Access Compliance Report

Public Rights-of-Way

(Curb Ramps)

Intersection ID: 48580	Main Street: SWEET_FLAG_CT	Cross Street: RUMPLE_RD	Location: SE
ADA ID: 84A9ECE09D4F	Ramp Type: Perp	Initial Pass/Fail: Fail	Overall Compliance: No
Severity Score: 12.5			
Codes/Mitigation Info/Possible Solution		Field Measurements/Component Compliance

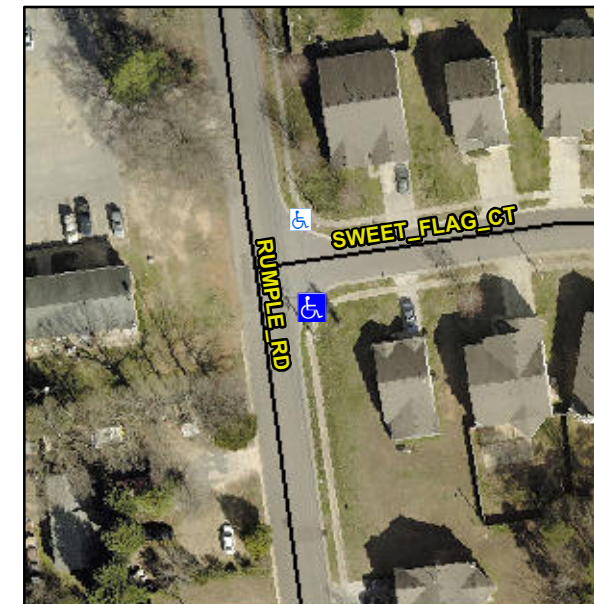
Not Found, R304.2.2

Compliance	Description	Data	Compliance	Description	Data
N/A	Ramp Length (in)	46.0	No	Ramp Slope (%)	8.4
Yes	Ramp Width (in)	48.5	Yes	Ramp XSlope (%)	0.3
N/A	Flare Type LT	N/A	N/A	Flare Type RT	N/A
N/A	Flare Slope LT (%)	N/A	N/A	Flare Slope RT (%)	N/A
N/A	Flare Traversable LT?	N/A	N/A	Flare Traversable RT?	N/A
N/A	Landing Length (in)	N/A	N/A	DWS Provided?	N/A
N/A	Landing Width (in)	N/A	N/A	DWS Contrast?	N/A
N/A	Landing Slope (%)	N/A	N/A	DWS Length (in)	N/A
N/A	Landing X Slope (%)	N/A	N/A	DWS Full Width?	N/A
N/A	Landing Curb? (Y/N)	N/A	N/A	DWS Offset (in)	N/A
N/A	Shared Landing?	N/A			
N/A	Gutter Ponding?	N/A	N/A	Gutter Slope (%)	N/A
N/A	Gutter Lip Ht (in)	N/A	N/A	Gutter X Slope (%)	N/A
N/A	Painted X Walk1?	No	N/A	Painted X Walk2?	N/A
	X Walk 1 Direction	To N		X Walk 2 Direction	N/A
N/A	X Walk 1 Width (in)	N/A	N/A	X Walk 2 Width (in)	N/A
	X Walk 1 Slope (%)	1.7		X Walk 2 Slope (%)	N/A
	X Walk 1 X Slope (%)	0.1		X Walk 2 X Slope (%)	N/A

Remove & Replace Entire Ramp.
